**STAFF REPORT FOR CALENDAR ITEM NO.: 11
FOR THE MEETING OF: November 18, 2021**

TRANSBAY JOINT POWERS AUTHORITY

As part of the Downtown Rail Extension (DTX) design development and optimization process, the San Francisco Peninsula Rail Program Executive Steering Committee (ESC) is supportive of configuration management changes recommended by the Integrated Program Management Team (IPMT) that include a reduction of approximately ½ mile of third track between Fourth and Townsend Station and approximately midway between Harrison and Folsom Streets, and modifications to the underground Fourth and Townsend Station to include changes to the station layout, specifically a two-track arrangement with a center platform serving Caltrain and two side platforms serving California High Speed Rail, resulting in an expansion of the station footprint under the Caltrain Fourth and King railyard.

Concept C Reduced - Third Track Reduction

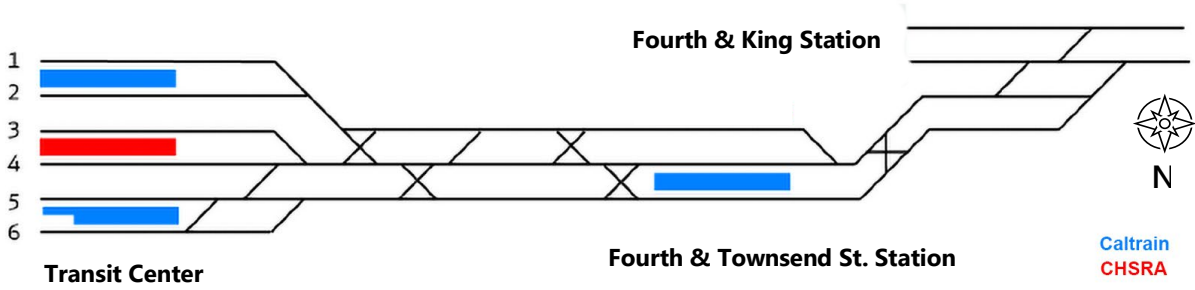
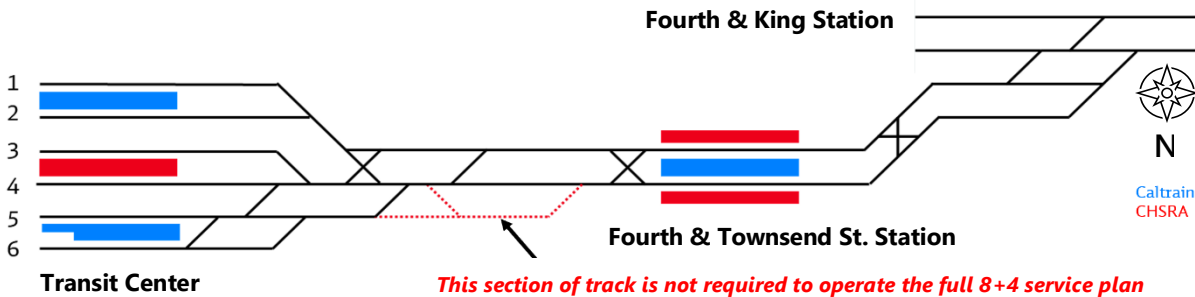
Reduction in the length of Third Track

Description: The baseline concept (See Attachment 1, Baseline Concept) included a three-track tunnel configuration beginning just west (outbound) of the Fourth and Townsend Station along

Townsend and Second Streets all the way to the throat section in the vicinity of Tehama Street. Through the aforementioned Operations Analysis and proposed reconfiguration of the Fourth and Townsend Station layout (described below), an alternative operating scenario was developed and tested with a reduced three track configuration utilizing an extended two track section of tunnel in conjunction with the proposed Fourth and Townsend Station layout. In this configuration, the three-track section need not begin until approximately mid-way between Harrison and Folsom Streets along 2nd Street (see Attachment 1, Third Track Reduction). This configuration does not change the project configuration inbound of this new three-track section, including the throat structure where the three tracks are expanded to six to access the six-track transit center layout.

Implications: Rail Operations consistent with the operators' service plans (8 peak hour each direction Caltrain trains and 4 peak hour each direction CHSRA trains) has been modeled under normal, perturbed, and contingency scenarios. In all cases, performance was consistent with operators' established service standards.

Because the construction of a reduced three track tunnel section would result in less excavation and construction material, and presumably a shorter construction schedule, environmental effects are presumed to be reduced and would likely require only an environmental technical memorandum to document the configuration change. This approach to National Environmental Policy Act (NEPA) has been informally reviewed with the Federal Transit Administration and favorably received although formal approval will be required during the Capital Investment Grants Project Development process, planned to commence in the next few months.

The reduced three track configuration was also analyzed in a through running configuration through a sketch-level planning study. No reduction in through-put at the transit center was observed.

Capital Cost Change: Compared to the baseline project (as defined in the FSEIS/EIR, adoption of this configuration change is estimated to result in a cost reduction of \$200,000,000, escalated to a mid-point of construction of 2027 and includes soft costs, contingency, and reserves.

Concept C Fourth and Townsend St. Station Modifications

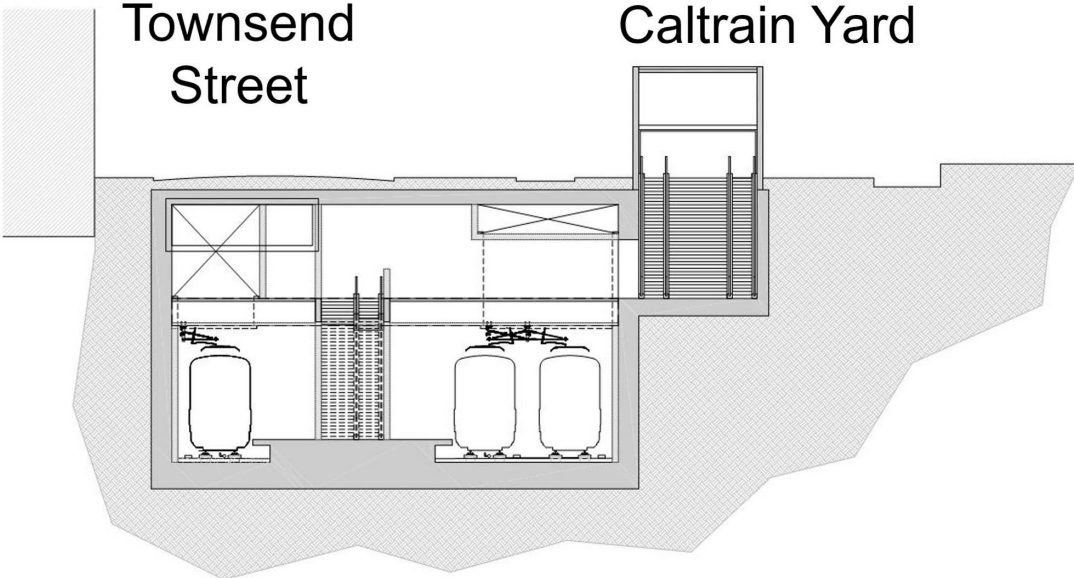
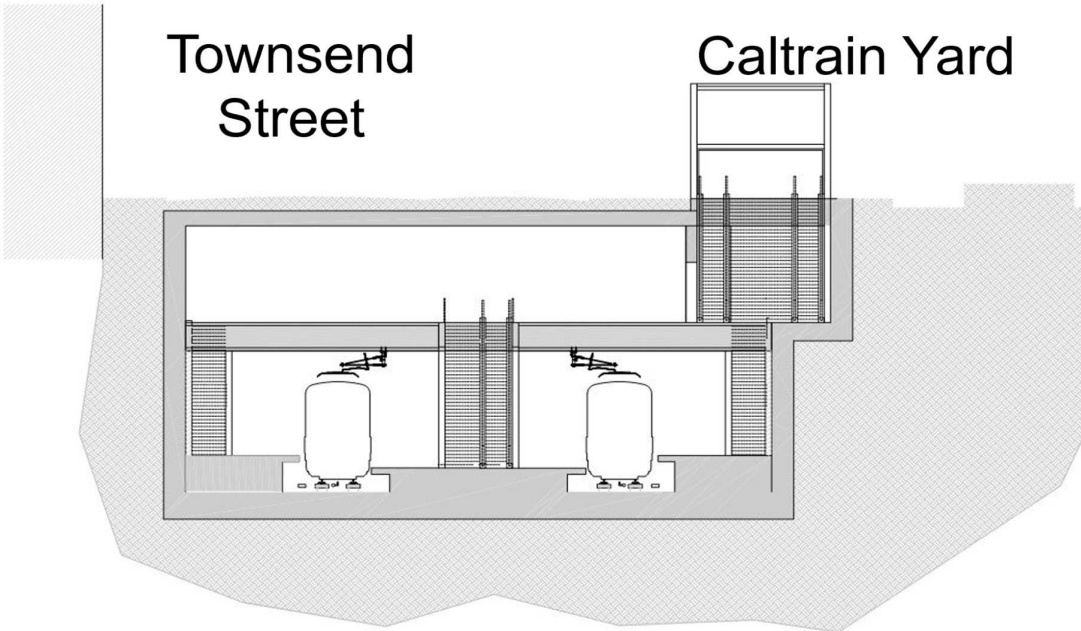
Description: The baseline concept (see Attachment 2, Transverse Section - Baseline Concept and Attachment 2, Aerial Plan View – Baseline Concept) includes a three-track single Caltrain platform configuration with CHSRA trains running through the station without stopping. No platform for CHSRA is provided in the Baseline Concept. Since the time this concept was developed, CHSRA has determined that they will serve the Fourth and Townsend Street Station and thus require platform and other limited passenger facilities. During the operations analyses, several alternative layouts for the station were evaluated to accommodate both Caltrain and CHSRA service at the operators' service plans (8 peak hour each direction Caltrain trains and 4 peak hour each direction CHSRA trains). The optimum solution was determined to include two tracks serving one center platform for Caltrain passengers and two side platforms servicing CHSRA passengers (see Attachment 2, Transverse Section – Station Concept C and Attachment 2, Aerial Plan View – Station Concept C).

Implications: The Fourth and Townsend Street Station Concept C arrangement permits service for both operators with the desirable dedicated platforms and results in the elimination of conflicting inbound and outbound train movements in the throat section, enabling the significant reduction of third track as discussed above.

Capital Cost Change: Compared to the baseline project (as defined in the FSEIS/EIR), adoption of this configuration change is estimated to result in a cost increase of \$150,000,000, escalated to a mid-point of construction of 2027 and includes soft costs, contingency, and reserves.

Street Level Plan View – Baseline Concept

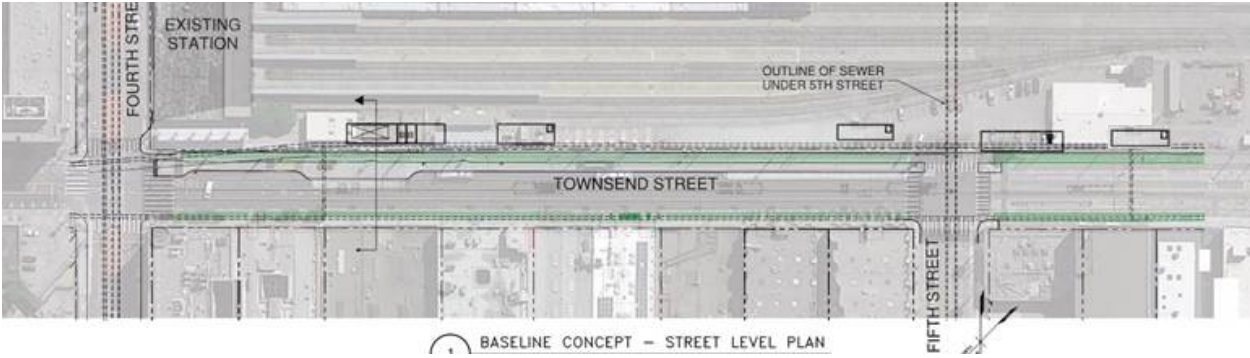
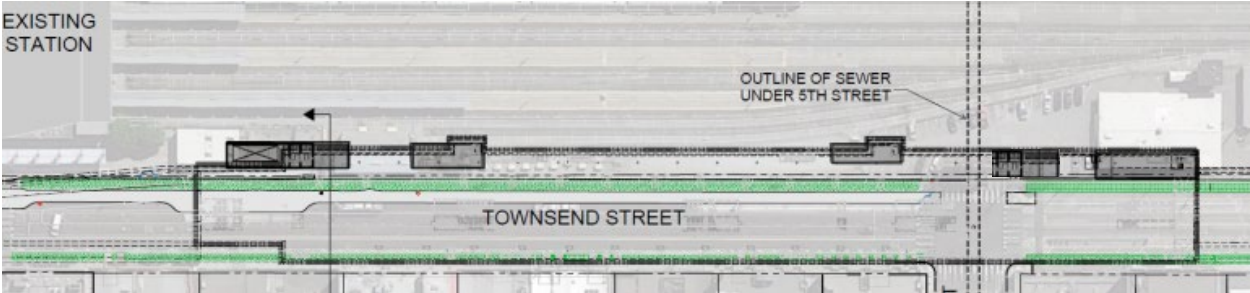
This proposed arrangement does increase the width of the station box, encroaching an additional approximate 17 feet into the Caltrain Fourth and King Yard, with some additional encroachment at the vertical circulation and ventilation structures along the station length. However, the relative impacts are reduced by the fact that the baseline concept includes several “bump outs” required for passenger access, emergency egress, and ventilation structures that extend beyond the station box and at the surface. Since Station Concept C largely incorporates these structures into the station box, the net additional encroachment is .16 acres. (see Attachment 2, Street Level Plan View – Baseline Concept and Attachment 2, Station – Concept C, and Summary Table).
